## Development Review Division

**SUBJECT:** SP21-064; Douglas 234 F6 L2 - Car Wash  
Review Comments 02

# CARWASH SITE PLAN

No.	REVISION	BY	DATE
 501 S Cherry St, Suite 300 Denver, CO 80246 303.672.7997 www.ees-us.com			
<b>SITE PLAN LOT 2</b> <b>CAR WASH</b> <b>COVER SHEET</b>			
PROJECT NO.:		TSD003.01	
DESIGNED BY:		LCG	
DRAWN BY:		JLG	
DATE:		09/13/2021	
P0.0

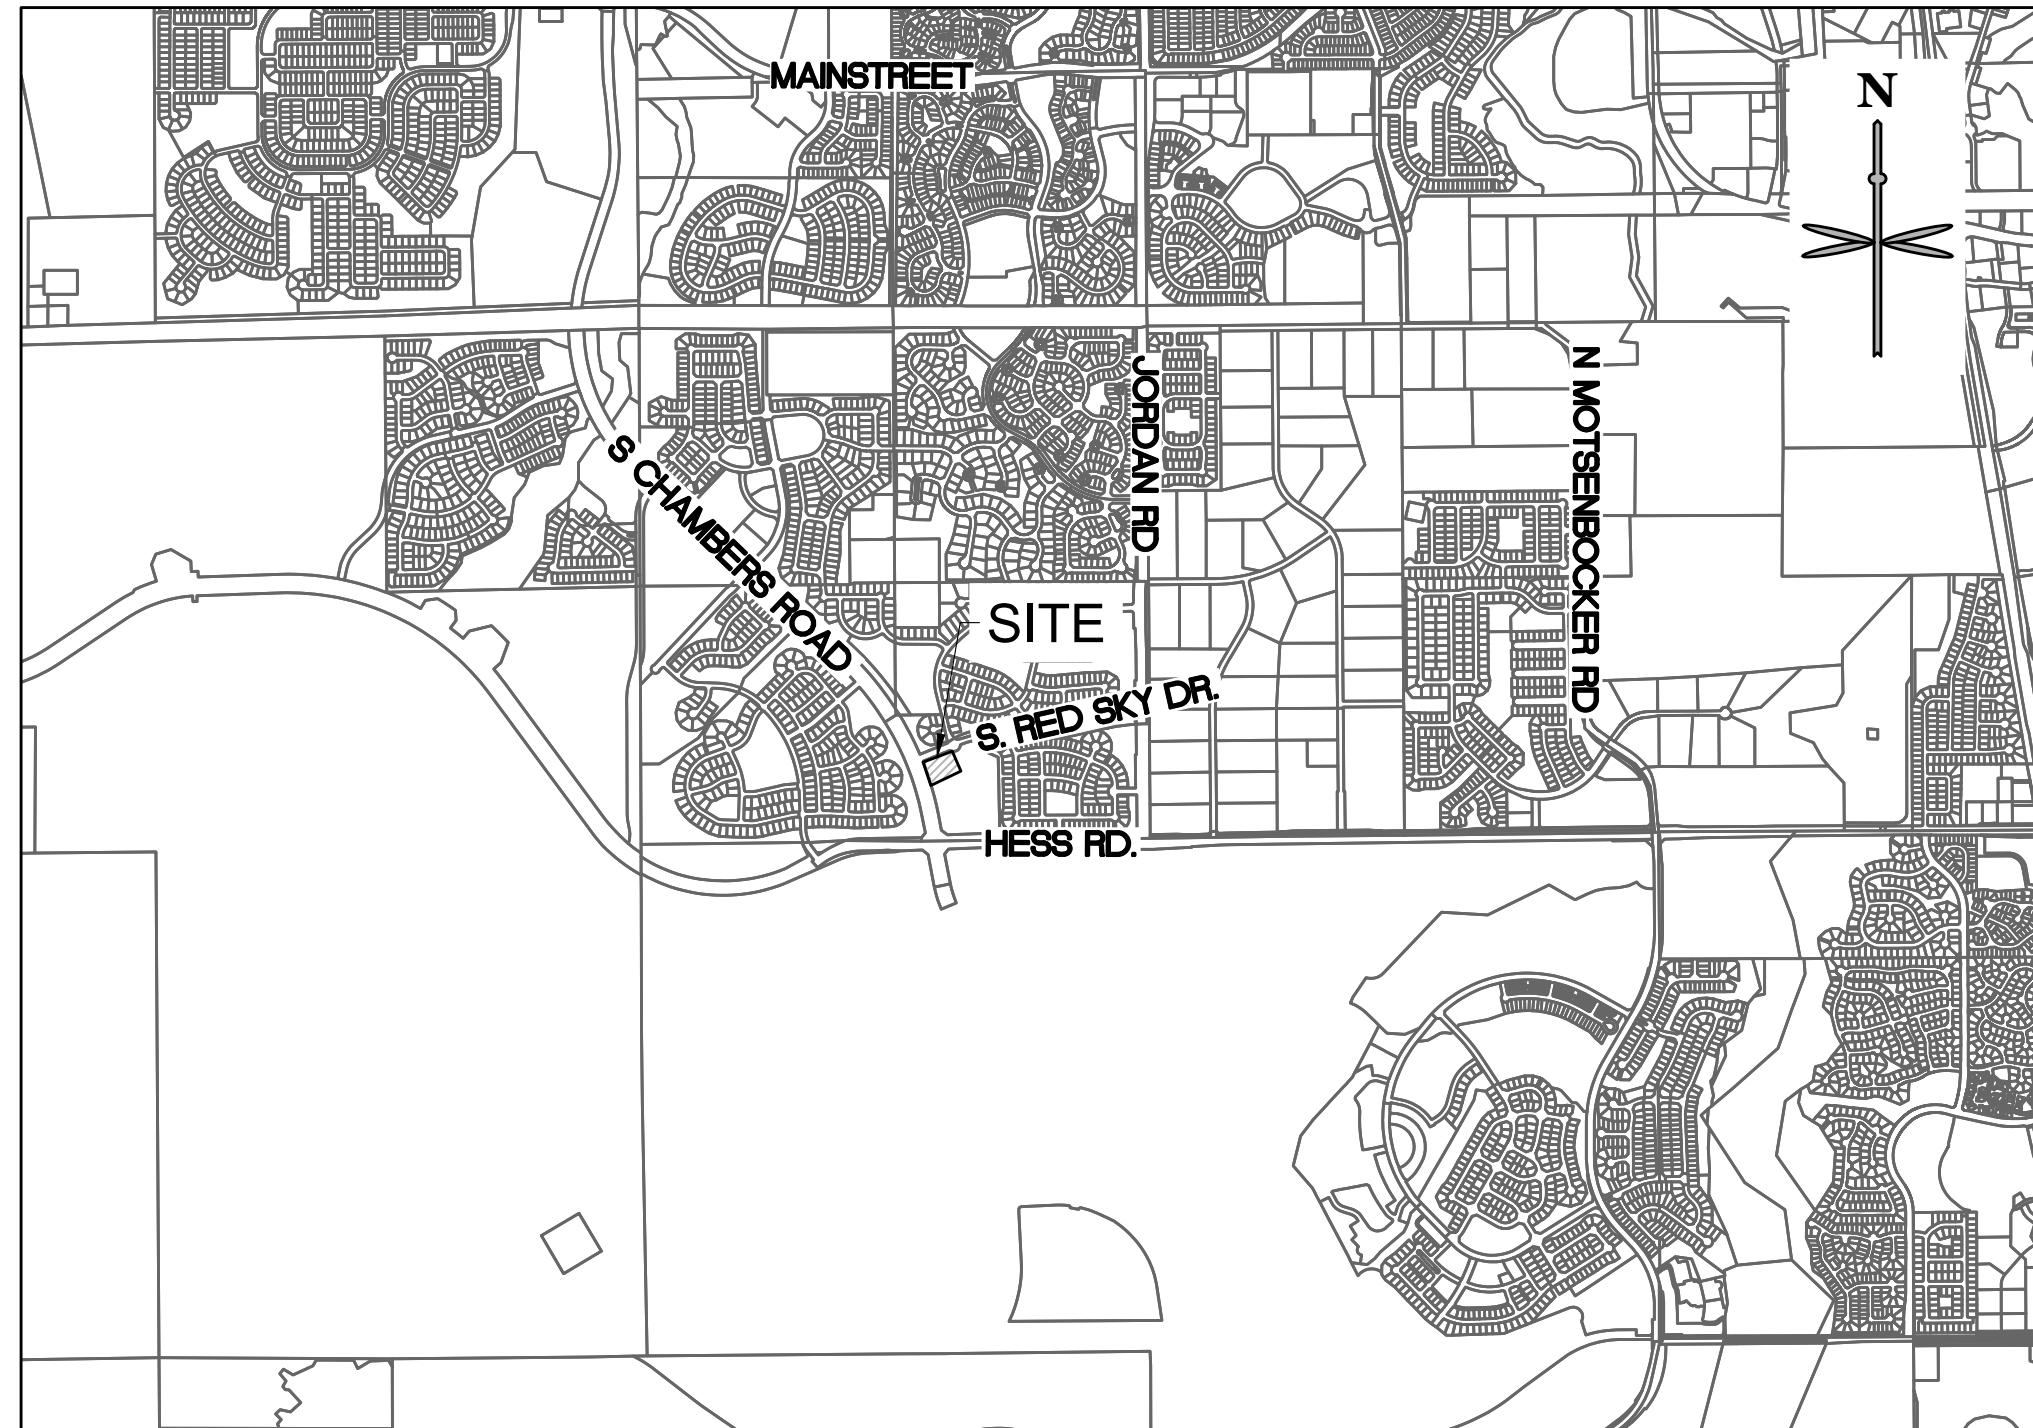
The Legal Description needs to be the main title-switch 1st and 2nd lines

## 1 LANDSCAPE PLAN

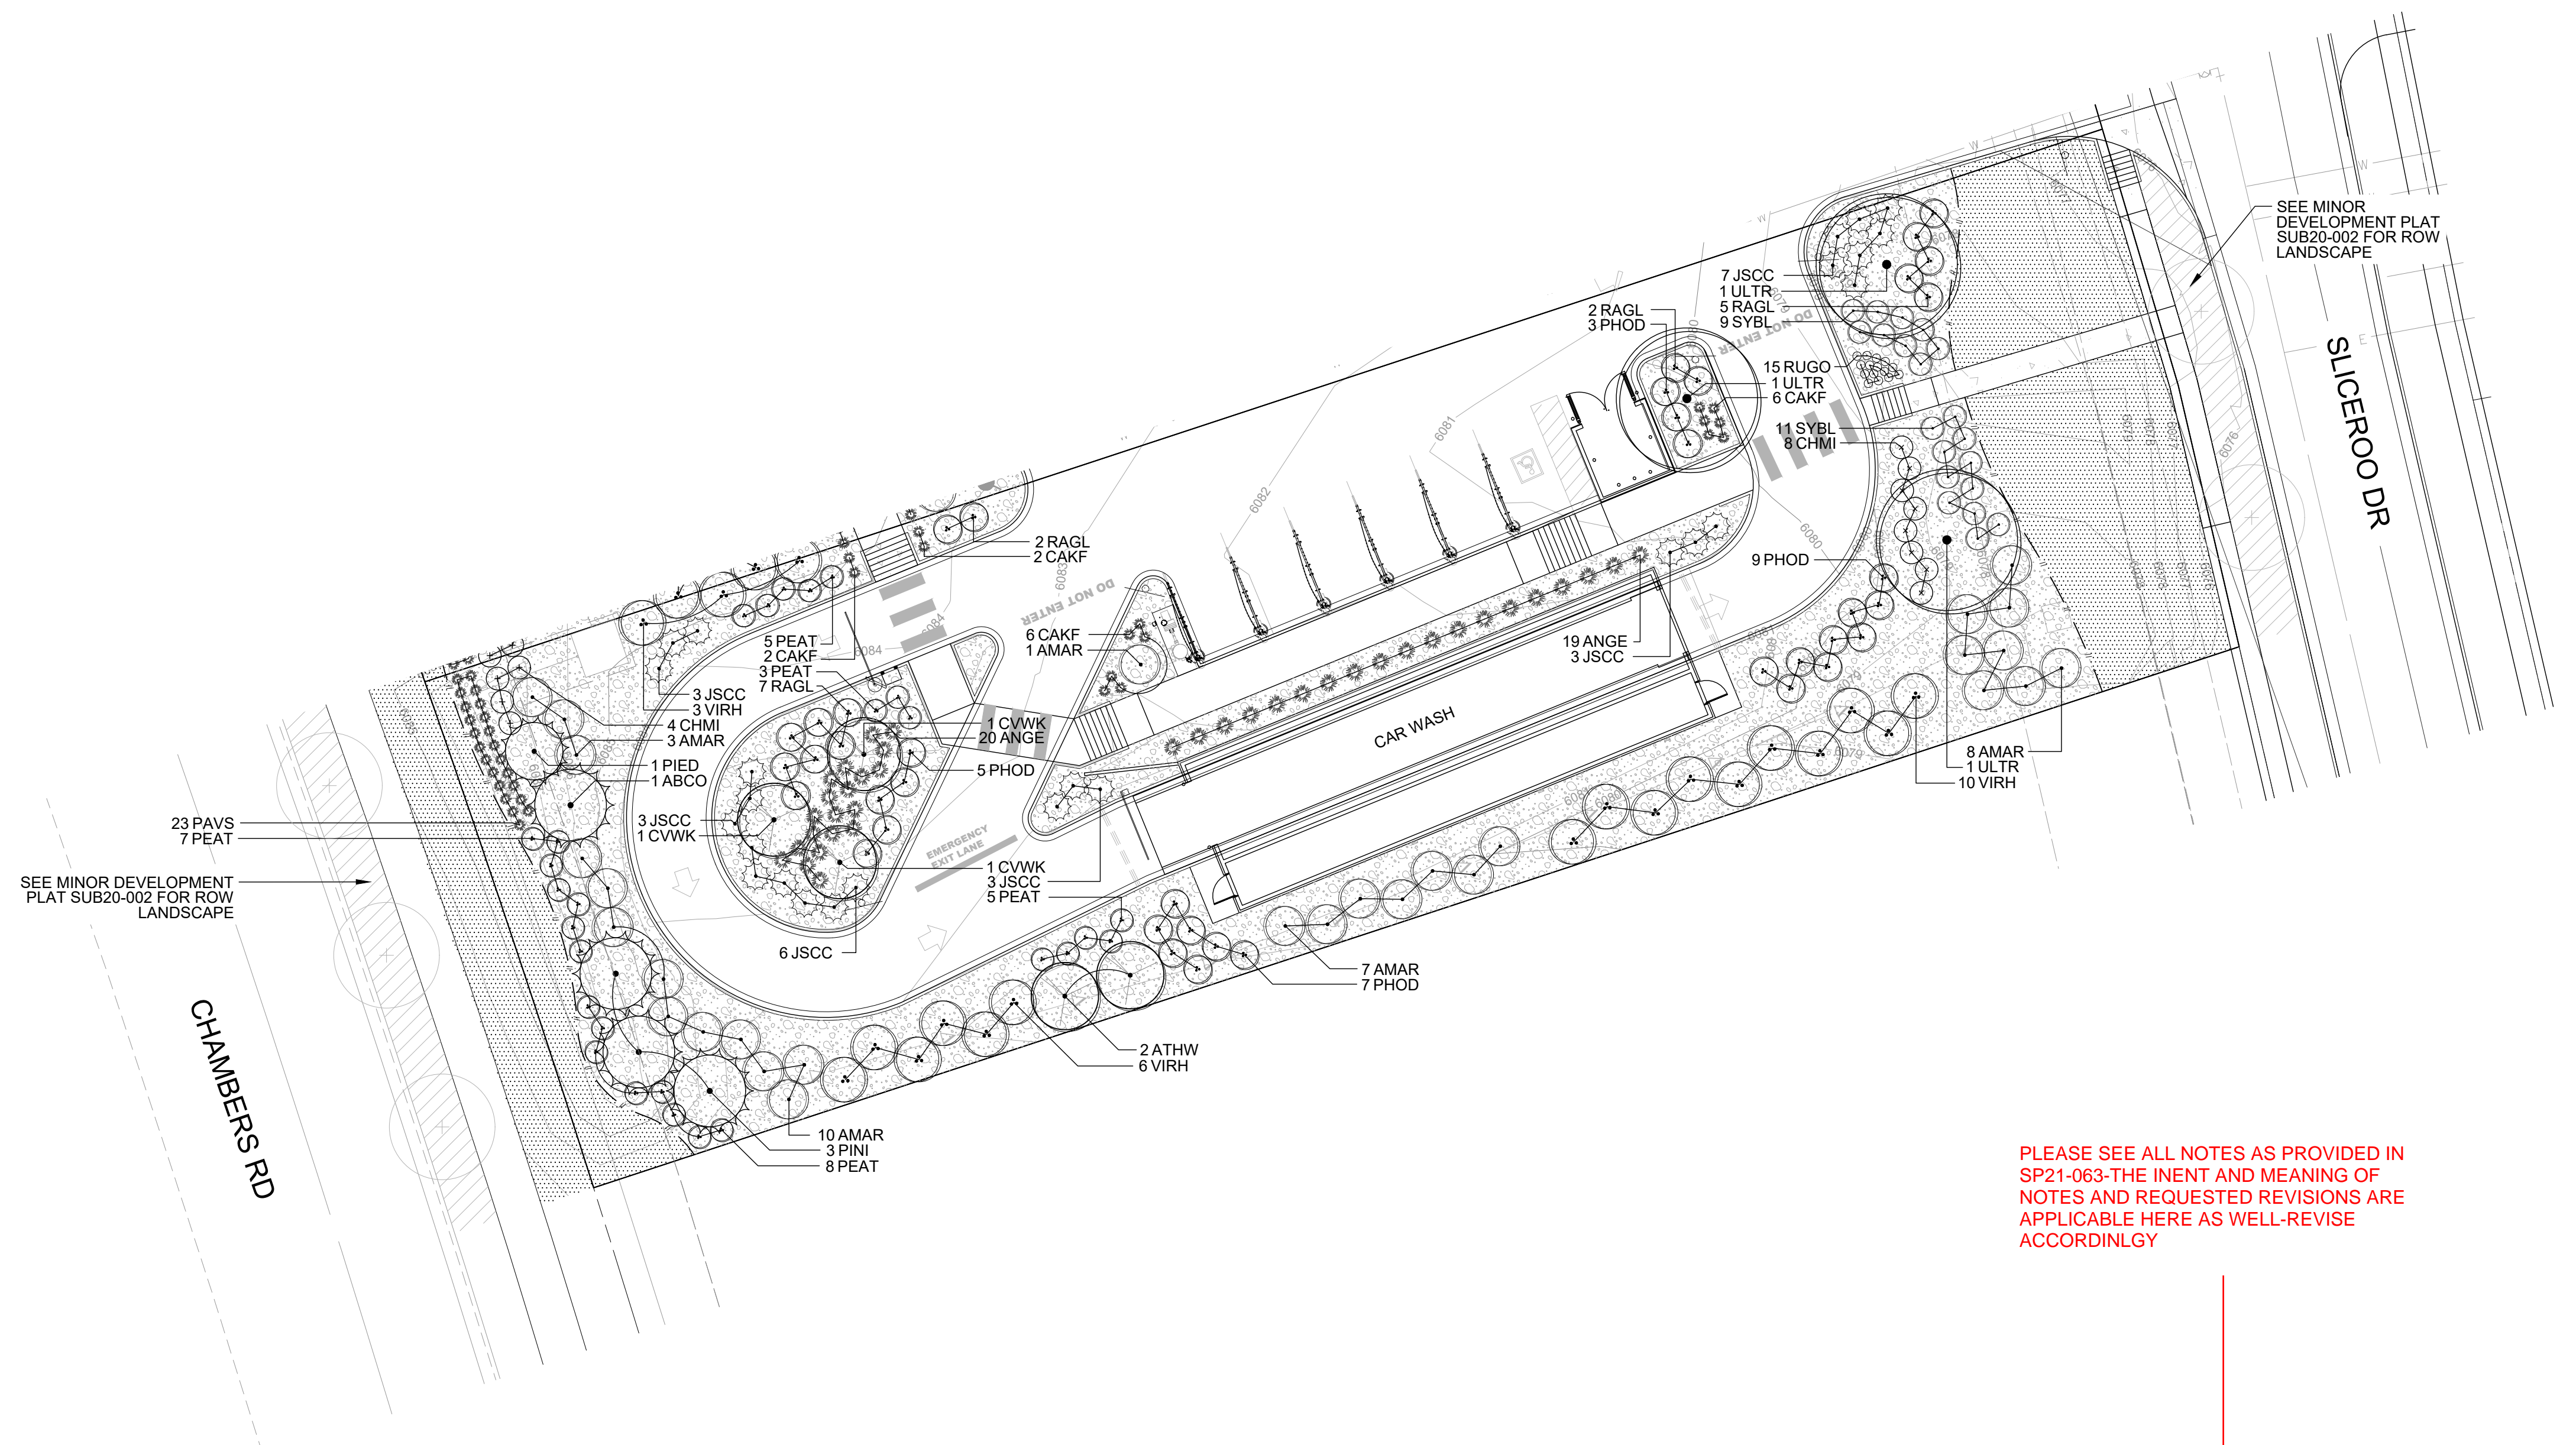
PLEASE SEE ALL NOTES AS PROVIDED IN SP21-063-THE INTENT AND MEANING OF NOTES AND REQUESTED REVISIONS ARE APPLICABLE HERE AS WELL-REVISE ACCORDINLGY
